Amendments to the Drawings

REMARKS/ARGUMENTS

FIG. 21A

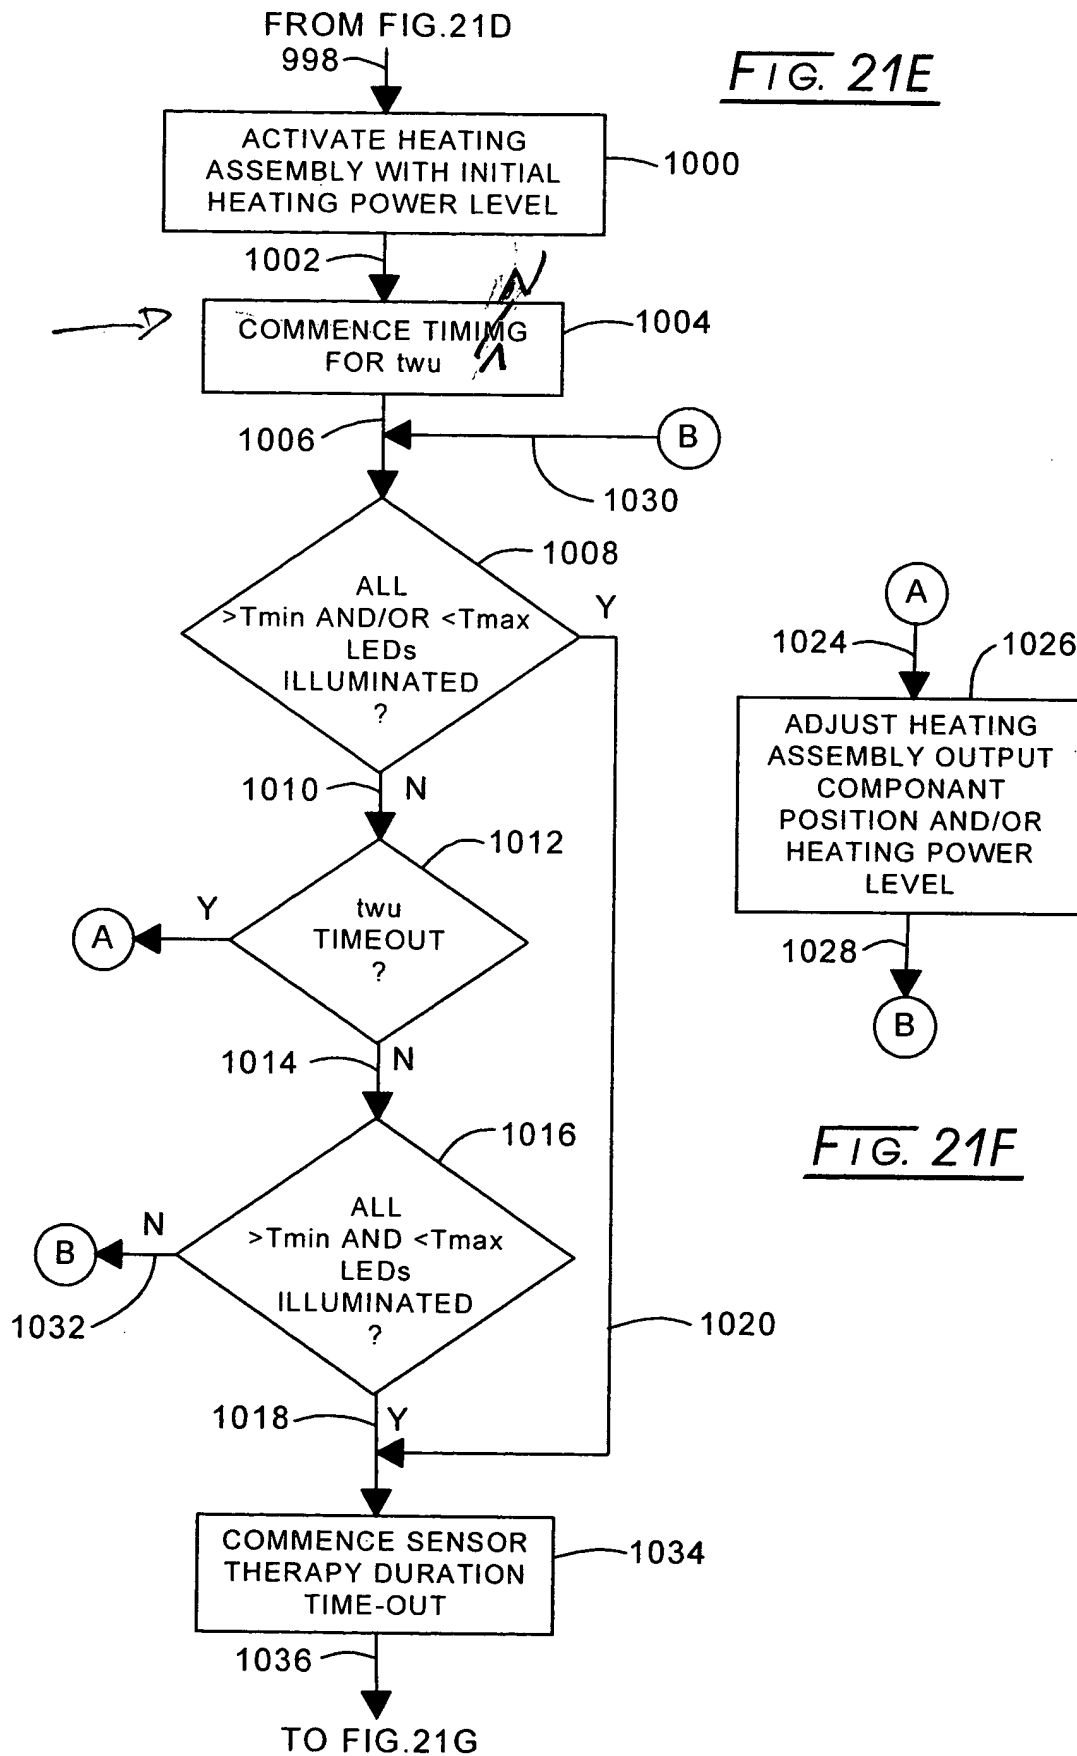
The attached substitute drawing sheets are for the correction of obvious typographical errors in the figure legends. The word "susceptibility" was misspelled in panel 894 of Figure 21A. The word "timing" was misspelled in panel 1004 of Figure 21E. The word "susceptibility" was misspelled in panel 1124 of Figure 23A. There was a missing space in panel 1228 of Figure 23E and the word "component" was misspelled in panel 1262 of Figure 23F. The word "susceptibility" was misspelled in panel 1334 of Figure 24A. The word "timing" was misspelled in panel 1444 of Figure 24E and the word "component" was misspelled in panel 1478 of Figure 24F. The word "susceptibility" was misspelled in panel 1616 of Figure 26A. The word "duty" was misspelled in panel 1692 of Figure 26D. The word "therapy" was misspelled in panel 1760 of Figure 26E. The word "bracketing" was misspelled in panels 2044 and 2048 and an extraneous underscore was deleted from panel 2056 of Figure 38A. The word "integral" was misspelled in panel 2080 of Figure 38B. The word "circulatory" was misspelled in panel 2098 of Figure 39A. The word "turn" was misspelled in panel 2240 and an extra word "console" was deleted from panel 2226 of Figure 39D. Substitute drawing sheets showing these corrections are submitted herewith.
